AVN-20220429 Problems with PCIe on TEBF0808 with TE080x

Company	Trenz Electronic GmbH
AVN Number	AVN-20220429
Title	AVN-20220429 Problems with PCIe
Subject	Information and remedy concerning problematic with PCIe (SoC as Host)
Issue Date	2022-04-29

#1 Use HSCL standard for PCIe CLK

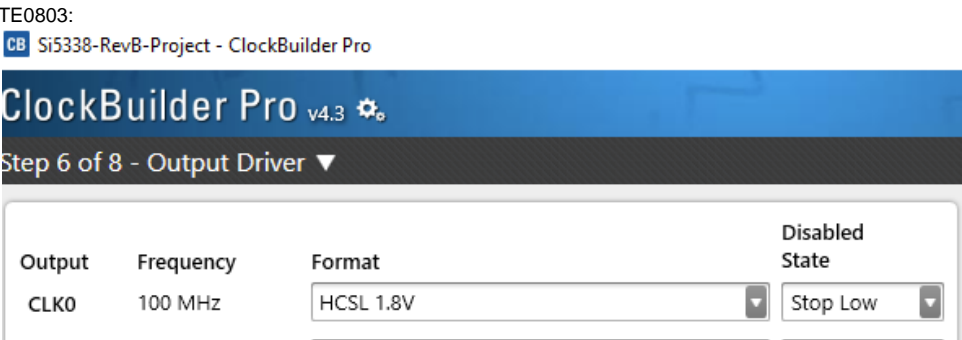
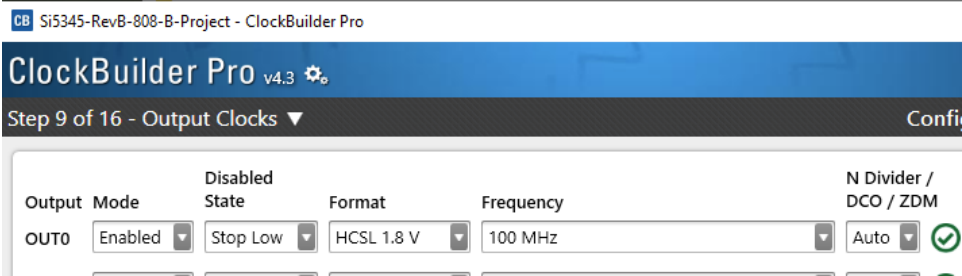
Type: Improvement
Reason: HSCL standard is more in compliance with PCIe specification and will improve PCIe stability.
Impact: Carrier which still use AC coupled reference CLK for PCIe on the carrier are recommended to be modify, see #2. Changes will be implemented in newer reference designs (2021.2 or newer)
